**WHATCOM COUNTY
PUBLIC WORKS DEPARTMENT**

**Public Authority Application to Federal Railroad Administration
Whatcom County, Washington-
Cove Rd., DOT #084795Y M.P. 87.655 Proposed Quiet Zone**

V. County Response to Notice of Intent (NOI) Comments:

ROAD RAILROAD GRADE CROSSING IMPROVEMENTS
MOUNTABLE CURB MEDIAN WITH REFLECTIVE
CHANNELIZATION DEVICES PLAN

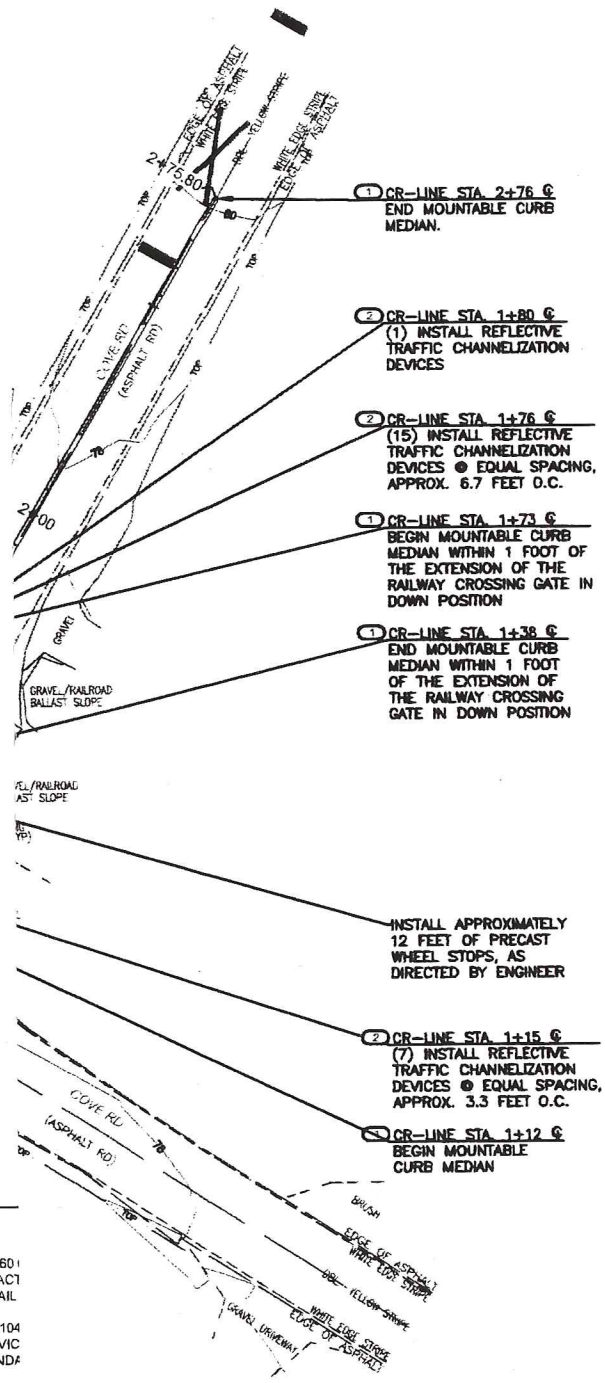
1. **Comment:** *Please note that we do not support the use of traversable medians and strongly encourage the County to use non-mountable concrete center medians with a minimum height of 7" instead.*

2. **Comment:** *Posts or delineators used on the channelization devices can bend or break; please note that the County is responsible for the cost and maintenance of these devices.*

3. **Comment:** *Further, additional signage and enhancements were discussed at the diagnostic meeting, including those regarding the hiking trailhead adjacent to the southeast quadrant. Please ensure these are implemented in accordance with the diagnostic notes.*

4. **Comment:** *Additionally, BNSF understood from the County that the County was going to build up the northwest quadrant of the crossing with gravel, as BNSF parks vehicles in that vicinity. Due to the median installation, BNSF will no longer be able to use a three-point turn to maneuver around the crossing and the gravel build up is necessary.*

The County recognizes that BNSF policy is to encourage the use of non-mountable concrete center medians. However, the proposed ASM's have been approved by the FRA to be used to mitigate for the absence of the train horn when creating a quiet zone. The calculations above summarize the effective risk reduction and identify this crossing as ultimately being safer than the current configuration upon the completion of installation of these ASM's. Also, having the ability to keep an inventory of mountable barrier parts on hand will allow the County to have a proactive maintenance program for these facilities. The non-mountable concrete center medians will require the County to contract out this work and will stall any maintenance efforts that may be required to preserve the effectiveness of these safety measures.

Maintenance of these devices was a deciding factor on the decision to use this type of durable rubber composite material. These prefabricated components can easily be installed and

replaced by County Forces where concrete work will need to be contracted out and is not done in house. The County will be able to keep replacement components on hand for responsive, efficient repairs and will conduct annual inspection, at a minimum, of these facilities.

The County will install an appropriate sized version of a pedestrian trail sign using the Manual on Uniform Traffic Control Devices sign W10-9. This sign will also be installed along all road approaches.

The County does recognize that the proposed mountable median with channelization devices will restrict BNSF vehicles and others from traversing them and will build up the northwest to accommodate BNSF's expectations.
